Access Compliance Report

Public Rights-of-Way

(Curb Ramps)

Intersection ID: 45761	Main Street: SOLACE_CT	Cross Street: GRANDEUR_RD	Location: NE
ADA ID: F08484A72E61	Ramp Type: PerpDiag	Initial Pass/Fail: Fail	Overall Compliance: No
Severity Score: 21.25			
Codes/Mitigation Info/Possible Solution		Field Measurements/Component Compliance

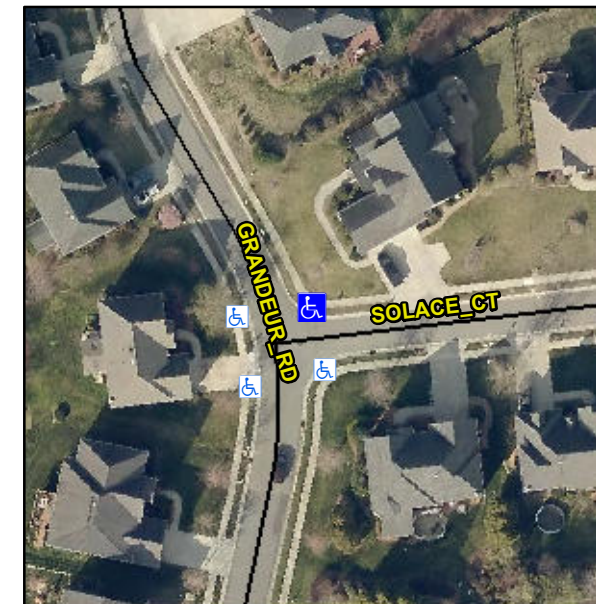
Not Found, R304.5.1, R304.5.3

Compliance	Description	Data	Compliance	Description	Data
N/A	Ramp Length (in)	46.0	Yes	Ramp Slope (%)	6.8
No	Ramp Width (in)	40.0	No	Ramp XSlope (%)	5.6
N/A	Flare Type LT	N/A	N/A	Flare Type RT	N/A
N/A	Flare Slope LT (%)	N/A	N/A	Flare Slope RT (%)	N/A
N/A	Flare Traversable LT?	N/A	N/A	Flare Traversable RT?	N/A
N/A	Landing Length (in)	N/A	N/A	DWS Provided?	N/A
N/A	Landing Width (in)	N/A	N/A	DWS Contrast?	N/A
N/A	Landing Slope (%)	N/A	N/A	DWS Length (in)	N/A
N/A	Landing X Slope (%)	N/A	N/A	DWS Full Width?	N/A
N/A	Landing Curb? (Y/N)	N/A	N/A	DWS Offset (in)	N/A
N/A	Shared Landing?	N/A			
N/A	Gutter Ponding?	N/A	N/A	Gutter Slope (%)	N/A
N/A	Gutter Lip Ht (in)	N/A	N/A	Gutter X Slope (%)	N/A
N/A	Painted X Walk1?	No	N/A	Painted X Walk2?	No
	X Walk 1 Direction	To W		X Walk 2 Direction	To S
N/A	X Walk 1 Width (in)	N/A	N/A	X Walk 2 Width (in)	N/A
	X Walk 1 Slope (%)	1.7		X Walk 2 Slope (%)	9.2
	X Walk 1 X Slope (%)	7.9		X Walk 2 X Slope (%)	1.6

Remove & Replace Curb Ramp With Two New Directional Ramps or Equivalent.
